CITY OF ALBUQUERQUE

April 17, 2023

**RE: SBMT Multi-Generational Center
1825 Edith Blvd. NE
Grading & Drainage Plan
Engineer's Stamp Date: 04/05/23
Hydrology File: H15D070**

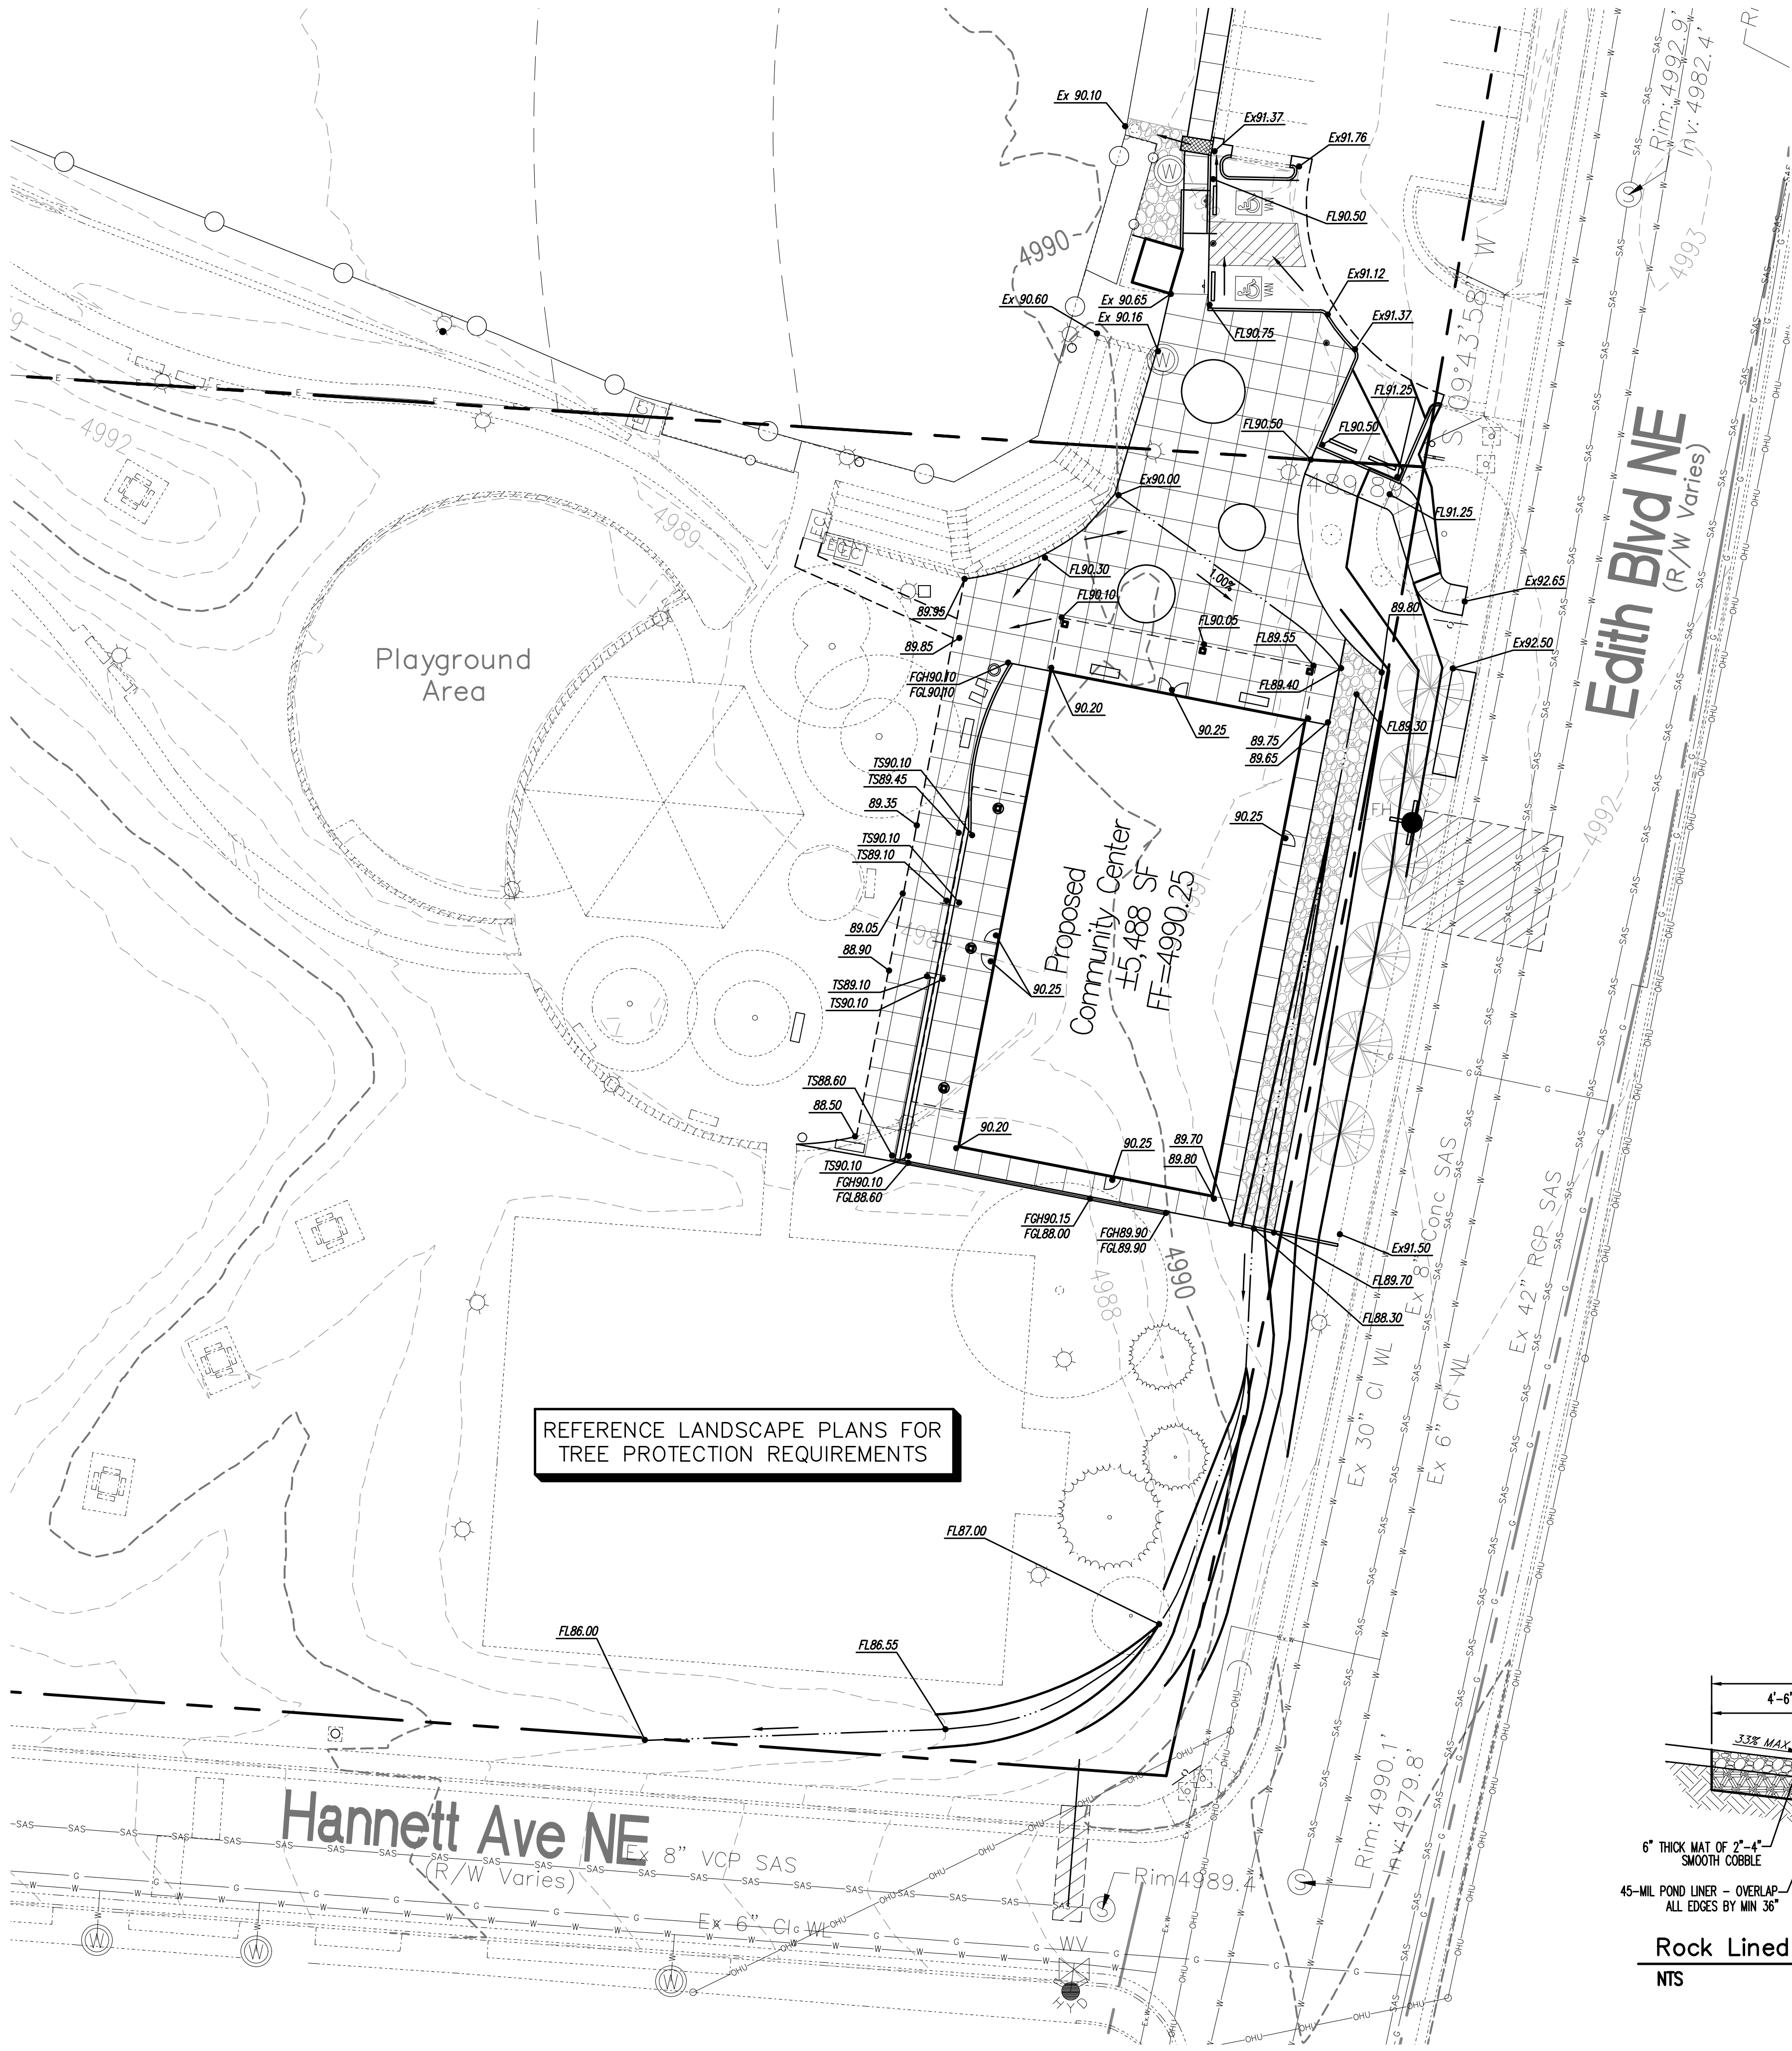
1. Please provide a legal Description of the property.
2. Please use the procedure for 40 acre and smaller basins as outlined in Development Process Manual (DPM) Article 6-2(a). Please provide both the existing conditions and proposed conditions for the 100 year-6 hour storm event.
3. Please follow the DPM Article 6-12 Stormwater Quality and Low-Impact Development for the sizing calculations. To calculate the required SWQV, multiply the impervious area draining to the BMP by 0.26 inches since this is a redevelopment site.
4. Please show and label the SWQ pond if this is going to be built. If payment-in-lieu is going to be used, then please fill out the SWQ waiver form and place the following note on the Grading & Drainage Plan. "Payment in Lieu for the required SWQ volume will be made (Amount = XXXCF x \$8/CF = \$XXX.XX)."
